**SUBJECT: COMANCHE PEAK NUCLEAR POWER PLANT, UNITS 3 AND 4
DOCKET NUMBERS 52-034 AND 52-035
SUPPLEMENTAL INFORMATION IN RESPONSE TO THE REQUEST FOR
ADDITIONAL INFORMATION REGARDING THE ENVIRONMENTAL REVIEW**

Comanche Peak, Units 3 and 4
Luminant Generation Company LLC
Docket Nos. 52-034 and 52-035

RAI REGARDING THE ENVIRONMENTAL REVIEW

QUESTION NO.: GEN-03 (3.6.1-1) HYD-23 (9.4.2.2.5-1) and LU-03 (5.5.1.1.2-1)

Figure 3.6-1 Sketch of Blowdown Water Treatment Facility Per Unit

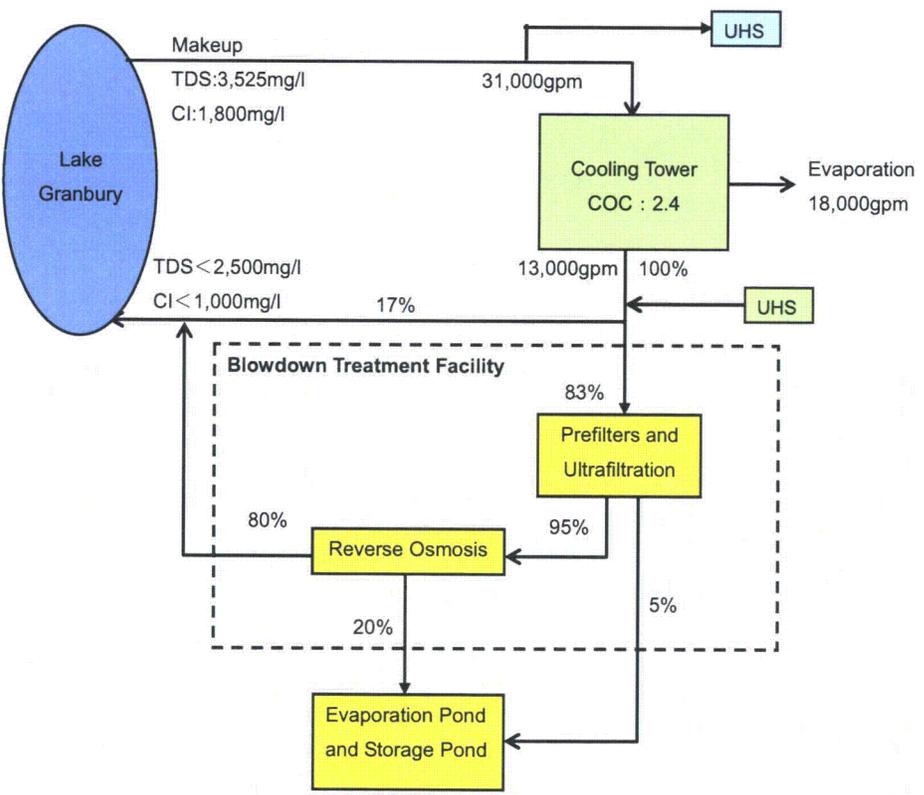
For the discussions below, refer to Figure 3.6-1. The normal flow path of BDTF at the design conditions will take approximately 83 percent of the blowdown flow and divert it to the facility for treatment. Approximately 95 percent of the diverted water is filtered water and will be sent to the R/O unit. Approximately 80 percent of the filtered water will become treated water and will be reverted back to the main blowdown stream. Approximately 5 percent of the diverted water is reject water from the filters and approximately 20 percent of the filtered water is reject water from the R/O units. The reject water above will become waste water, which will be backwash containing the rejects from pre-filters, ultrafilters, and R/O membranes and will be routed either directly to the misters or the storage pond. If there are insufficient misters available (due to maintenance) to evaporate the total amount of design flow, the excess will be diverted to the storage pond and then be sent to the misters when load demand improves. New Subsection 3.6.1.4 that discusses the BDTF flow process has been added to the ER.

For the discussions below refer to Figure 3.6-1. The normal flow path of BDTF at the design conditions will take approximately 83 percent of the blowdown flow and divert it to the facility for treatment. Approximately 95 percent of the diverted water is filtered water and will be sent to the
